Project	IEEE 802.16 Broadband Wireless Access Working Group < http://ieee802.org/16 >	
---------	--	--

Title	Transmission of the last complete SDU without subheader	
-------	--	--

Re:	This contribution is response to call for contribution about IEEE802.16e-D2	
-----	---	--

Abstract	This contribution is to propose the effective packing and fragmentation algorithm.	
----------	--	--

Figure 1 "insufficient room in a MAC PDU"

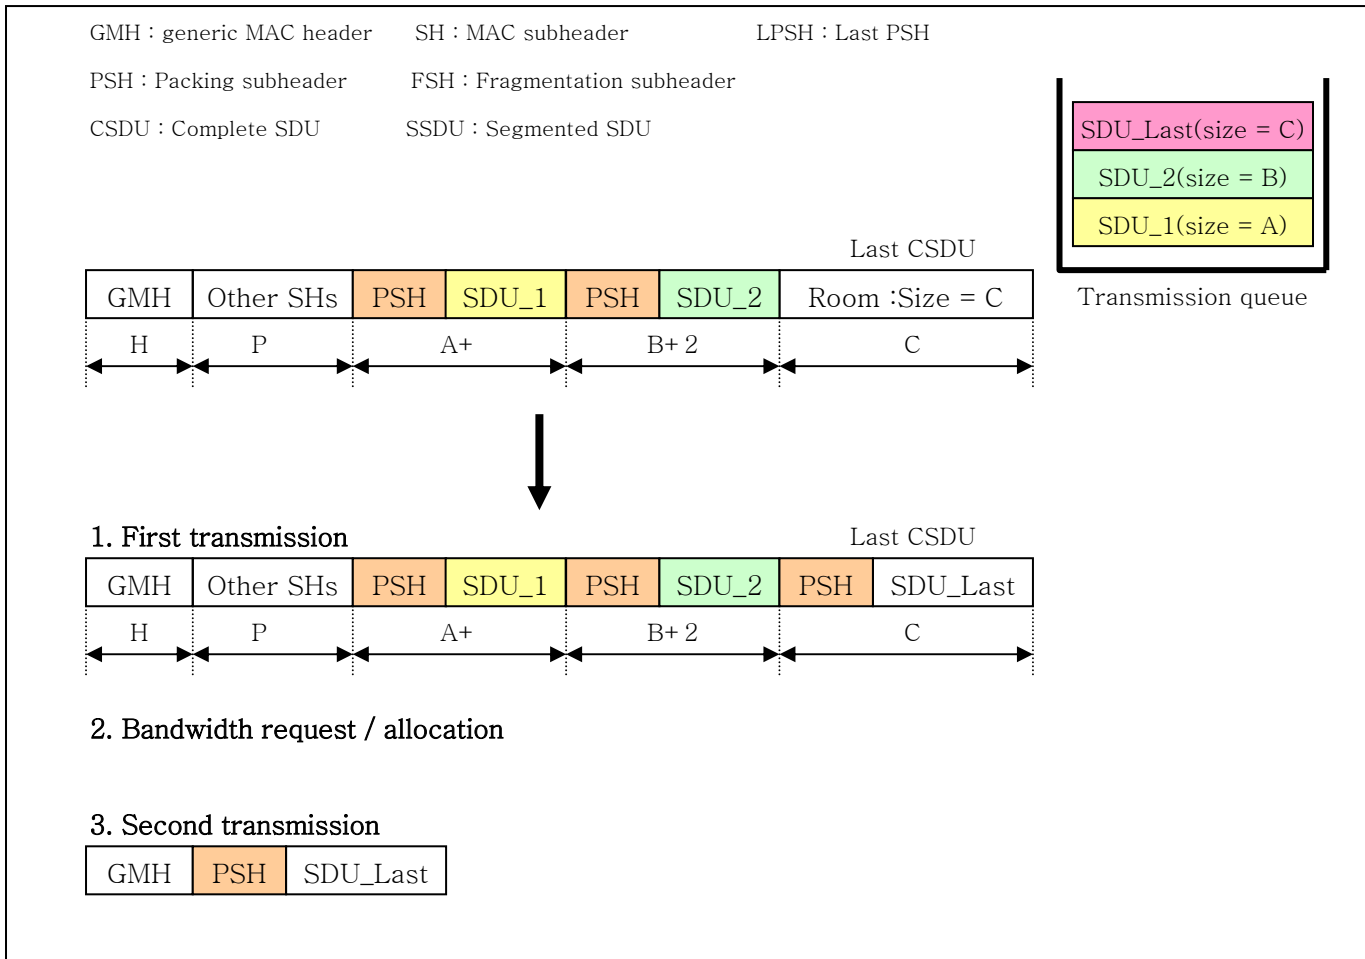
Now we can imagine the following situation shown in figure1. If the room of the MAC PDU is equal to 'C' ~ 'C + (PSH size - 1)', transmitter shall perform 1, 2, 3 in figure1.

Figure 2 "SDU_Last a MAC PDU/ Without packing subheader"

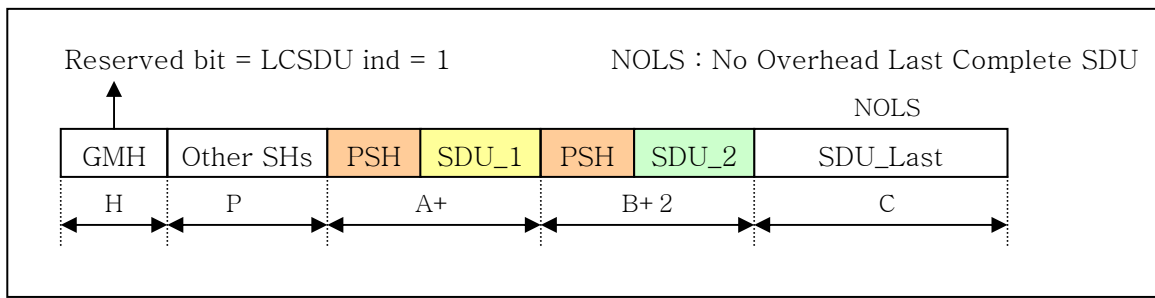
Following table helps the transmitter to send the last complete SDU and the receiver to receive the last SDU without packing subheader.

The 1bit of the 2bits 'reserved' in generic MAC header can be used to indicate that the MAC PDU contains more than one packed payload and NOLS. That is to say, 1bit 'reserved' bit may be used as 'NOLS presence' bit. NOLS stands for the last complete SDU with no overhead in that MAC PDU.

When the 'C' ~ 'C + (PSH size - 1)' situation happens, transmitter sets 'NOLS presence' = LCSDU ind bit to 1 and inserts NOLS payload without PSH into the corresponding MAC PDU and receiver shall decode the 'NOLS_Presence' bit and unpack the NOLS payload from the received MAC PDU.
